**From:** [Rachel Vickers](#)  
**To:** [knottworks@gmail.com](mailto:knottworks@gmail.com); [Laura Mounce](#)  
**Cc:** [Brent Bybee](#); [Geoff Wullschlager](#)  
**Subject:** Incomplete Letter for 06SPR-23  
**Date:** Thursday, September 28, 2023 4:36:00 PM  
**Attachments:** [2023.09.28-IncompleteLetter-06SPR.23.pdf](#)  
[image001.png](#)

## INCOMPLETE LETTER

*SUBJECT: 06SPR-23, Knottworks Construction, 16565 Reed Road, La Pine, OR 97739*

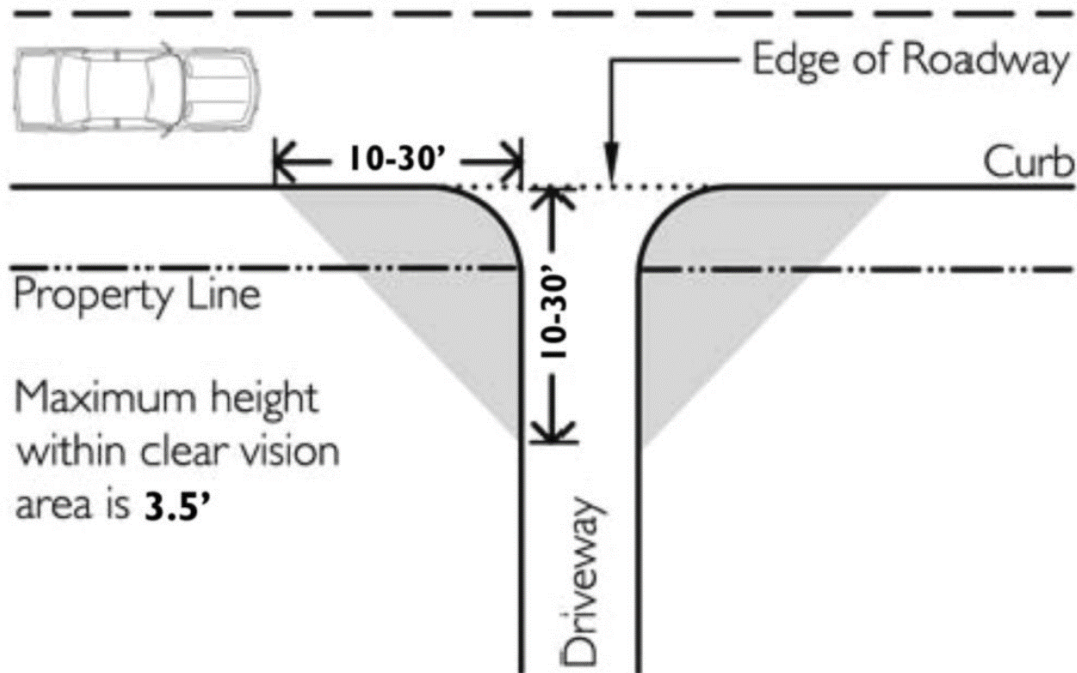
**STAFF COMMENT:** Clear vision triangles were identified on the site plan, however staff could not determine the dimensions of the clear vision triangles to see if they complied with LPDC. Based on the right of way width, the clear vision triangle must be 30 feet. Please submit an updated site plan that includes dimensions.
